Oatlands Gaol Structural Report

***Oatlands Gaoler's Residence
Structural Report***

***Oatlands Gaol
Structural Report***

This Report follows on and is an addendum to the Remedial Works Report 2004 on the Oatlands Gaol by Barry and Eleanor Bjorksten.

AIR VENT DRAIN

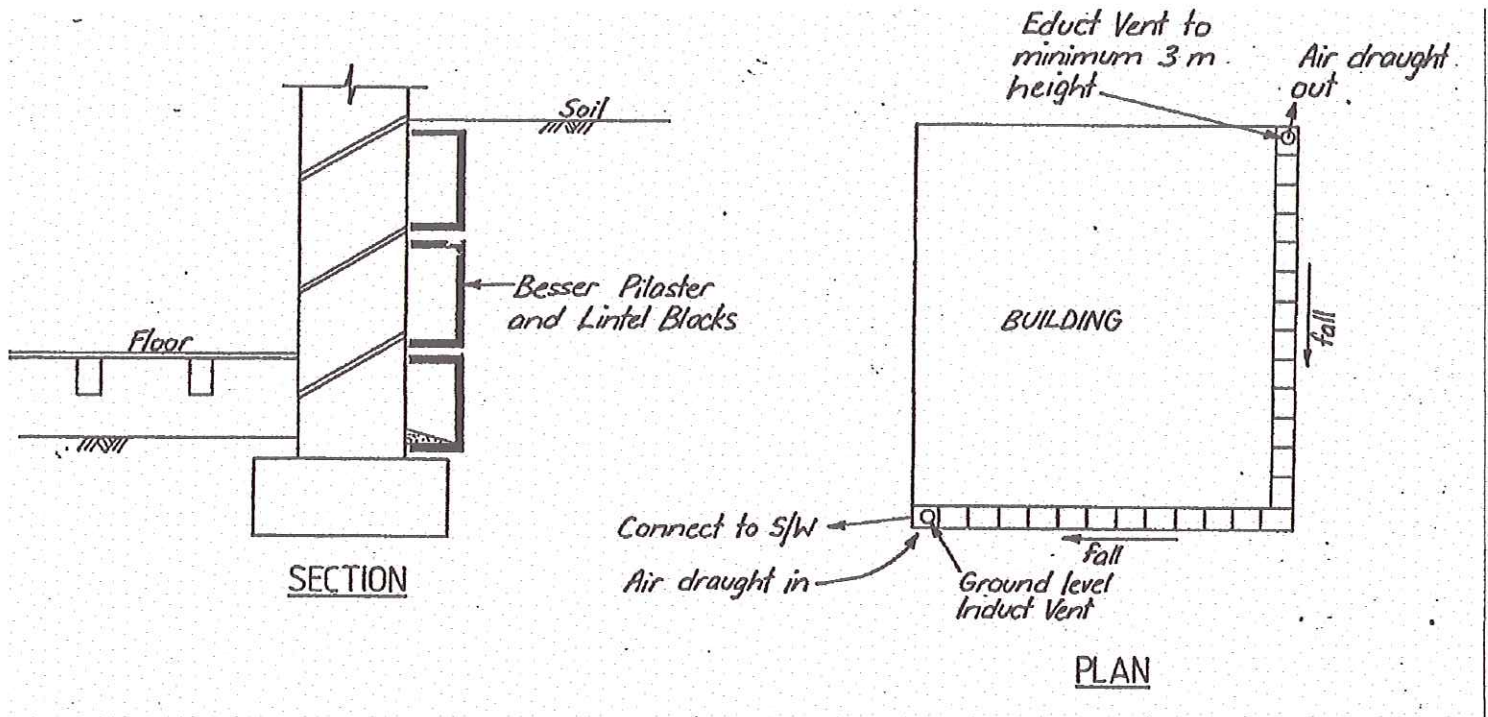
I have developed an air vent drain technique as the attached description and recommend that it be constructed to Mason Street road level on the top side of the affected wall.

- remove wet soil from against the exterior building walls.
- by being laid open jointed they pick up surface and subsurface waters and lead them away from the building.
- provide an air cavity below ground level against the building walls.
- by containing an induct vent grate at their lower end and an educt vent pipe at their upper, provide a drying air current against the wall and ventilate the air vent in the same manner as sewer pipe ventilation.
- Use concrete pilaster or lintel blocks with open face against the wall so as to allow the air draught to dry out the wall below ground level.

Photo 2. Note lack of headers and vertical stone cracking between windows indicating ashlar movement and delamination

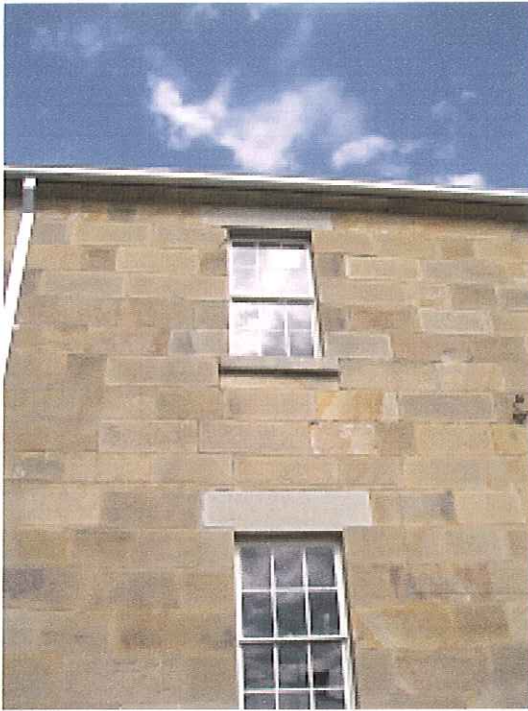
Photo 3. Site soil bedding and variable thickness.

Photo 4.
The roof lands on the outside ashlar.
Note the joists on the right are parallel to the wall plate and there is no connection between the roof and the joists.

Photo 5.
Note the very slender roof members which readily deflect or buckle in compression.
Compression member span divided by member minimum thickness should not exceed 50.

Photo 6.
Rot of ceiling tie beams with water entry.
A supporting wall has been removed increasing beam span and deflection.

Photo 7.
As photo 6 from above.
The beam deflections have dropped the ends of the joists which the beams support.

Photo 8.
Typical roof construction with inadequate ridge support, readily buckled struts and braces and with all roof timbers undersized.

FIGURE 1

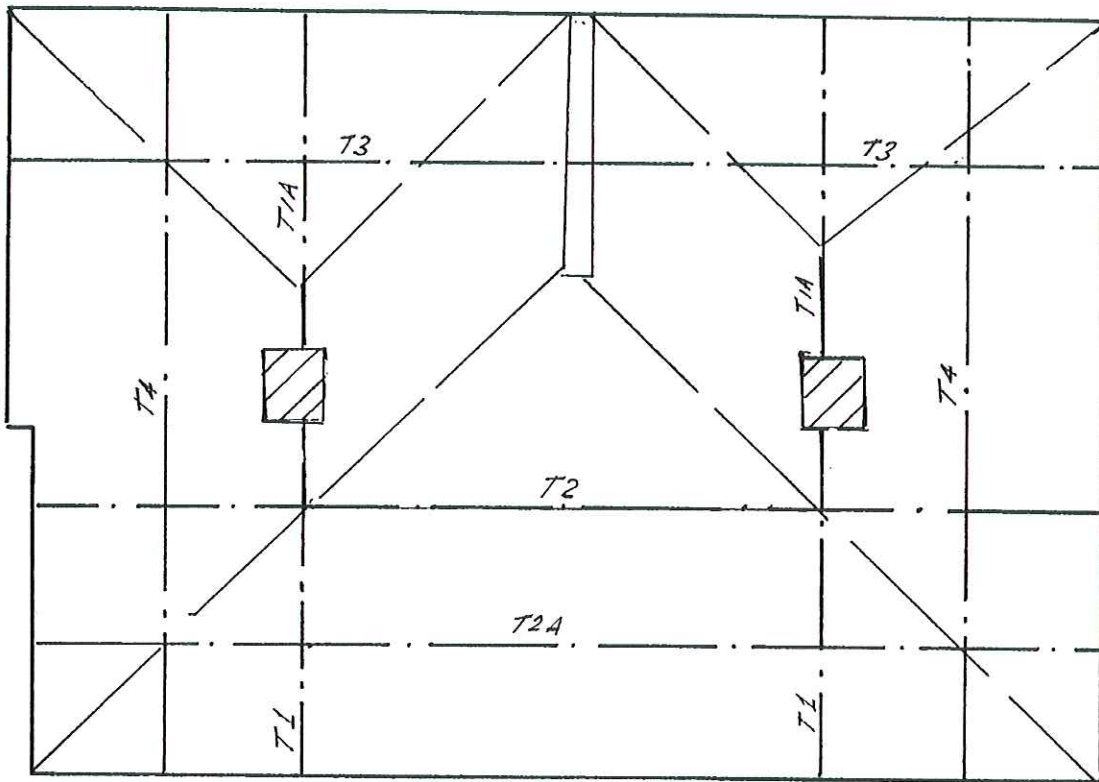
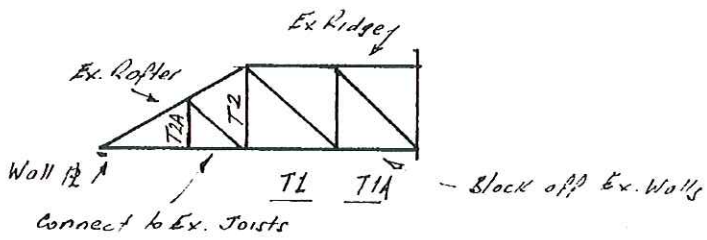
The roof is best practice stiffened by constructing timber trusses along the roof ridge lines and as truss underpurlin support to the roof rafter centres with truss bottom chords simultaneously stiffening the ceiling joists under. The trusses will additionally tie the roof structure to all the building walls.

Figure 1 attached shows the concept.
